MIL-S-19500/166C(NAVY)
AMENDMENT 3
18 December 1968
SUPERSEDING 1/
AMENDMENT 2
25 April 1966

MILITARY SPECIFICATION

SEMICONDUCTOR DEVICE, TRANSISTOR,

TYPE 2N599

Figure 1. Physical dimensions of transistor type 2N599 (TO-5).

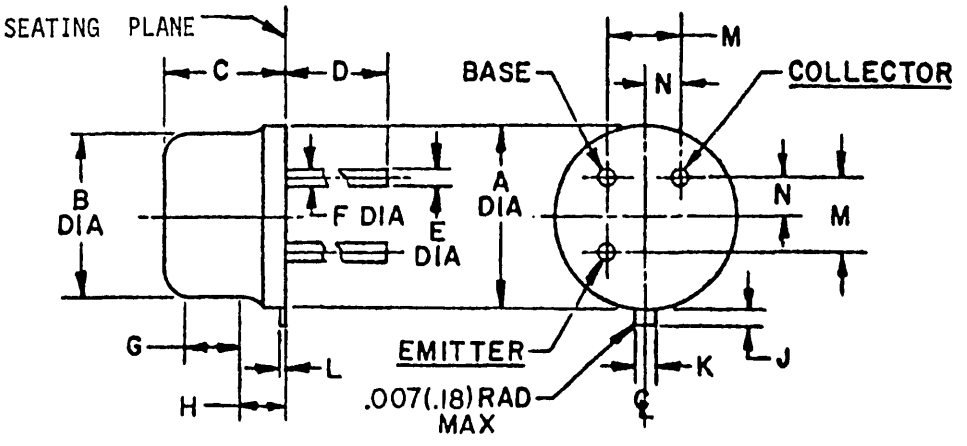
Paragraph 1.2: Delete "To-9 (see figure 1)" and substitute "See figure 1 (TO-5)".

Figure 1: Delete and substitute the attached figure 1.
